Project:	Highways England Spatial Planning Arrangement	Job No:	60540307
Subject:	A1 - Burghley Estate Stamford	Date:	16 February 2018
HE ref:	APS3 – Leics – Lincs - Rut	Task:	L0004

This Technical Note reviews the Land North of Stamford A1 Access Report Update dated January 2018, prepared by Peter Brett Associates LLP (PBA) on behalf of Burghley Estates and Larkfleet Homes to support the allocation of a proposed residential-led mixed use development through the South Kesteven and Rutland Local Plans revision. The proposed residential-led development comprises:

Figure 2/3 AP All-Purpose Road Merging Diagram

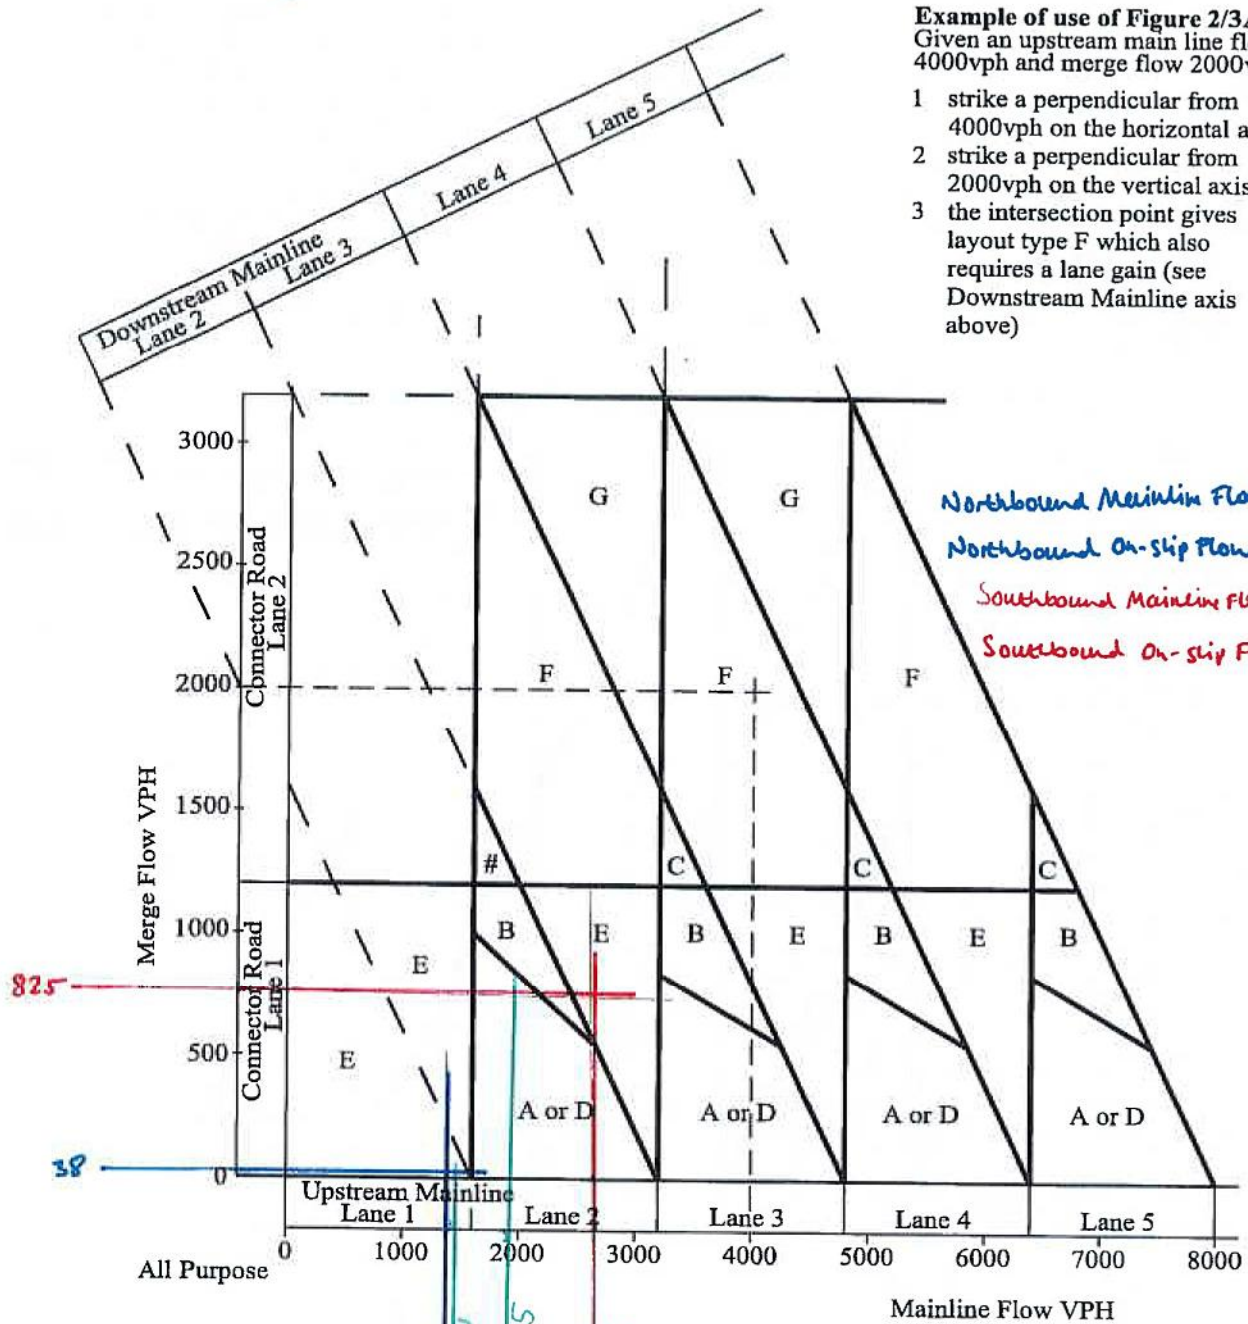
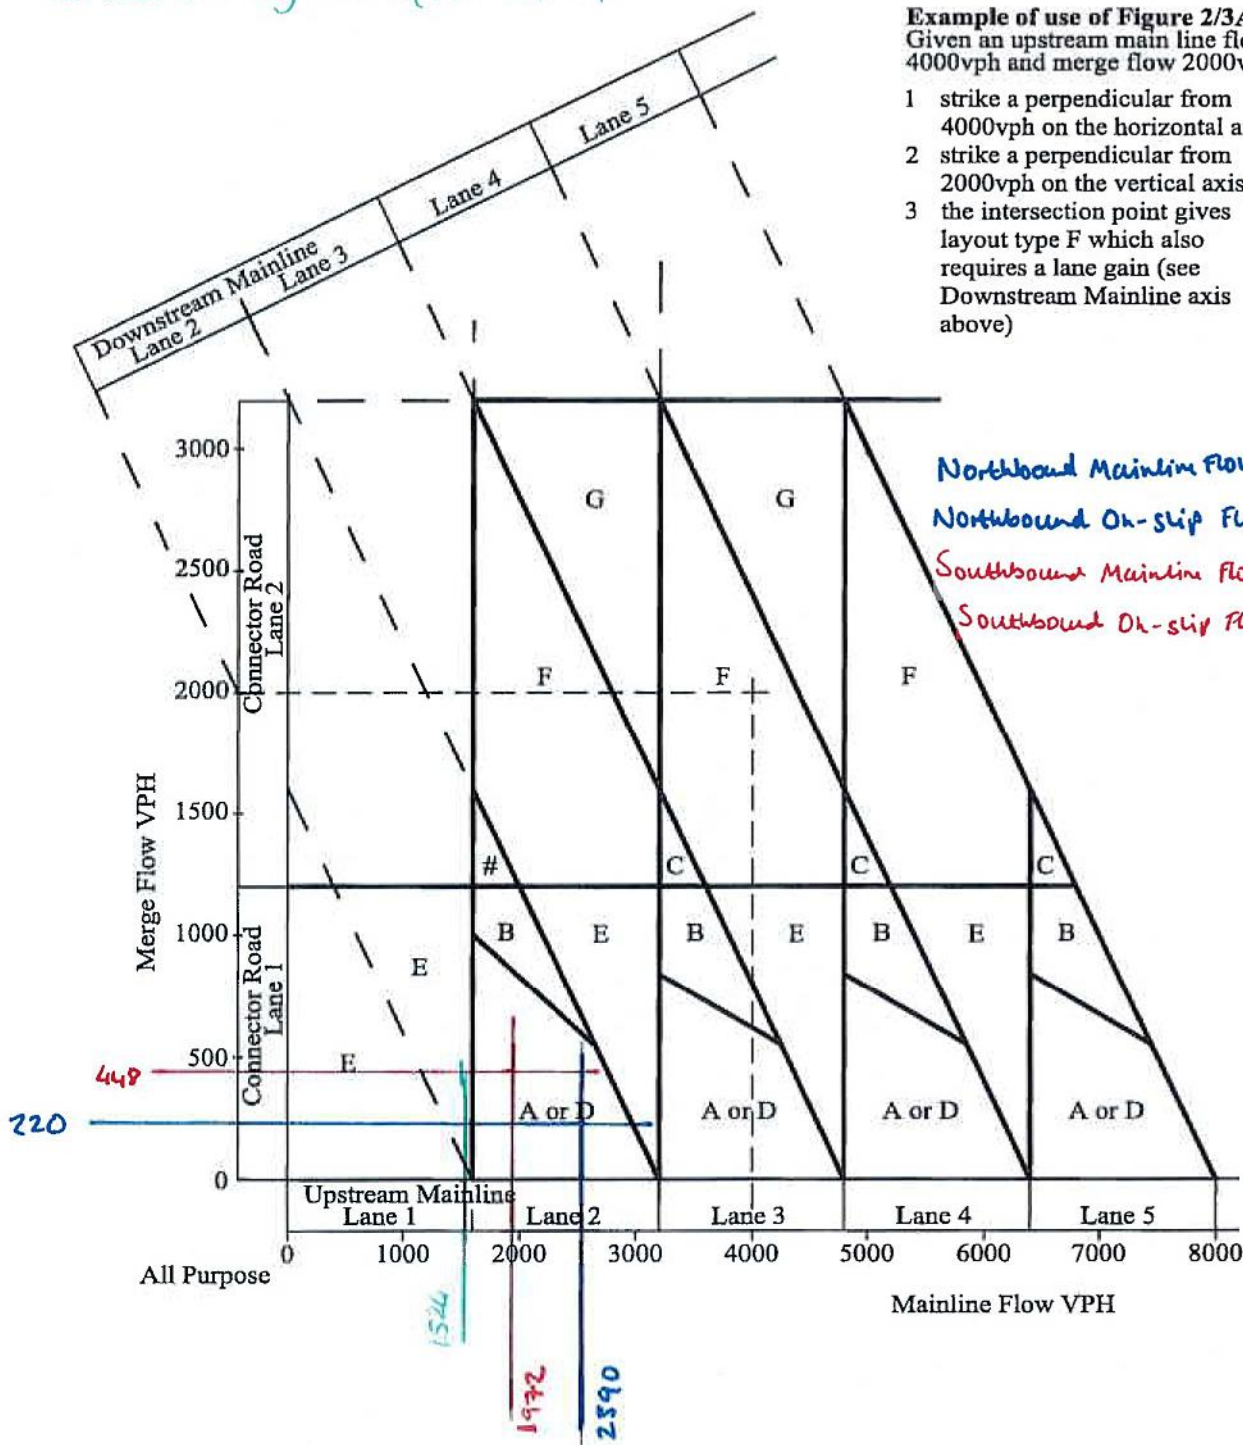
The resulting merge and diverge diagrams that AECOM has prepared can be found in **Appendix A** together with PBA's assessments. As it can be seen, some flow inconsistencies have been identified in between PBA's and AECOM's assessments. However, these are only relevant at the A1 Southbound On-slip assessment, for which PBA was identifying the need of a lane gain while AECOM did not.

Based on the assessment undertaken by AECOM using the 2036 Do Something flows extracted by the Updated Stamford model, it appears that there is no need for any lane gains/drops of the current merges and diverges at the A1 / A606 Empingham Road Junction.
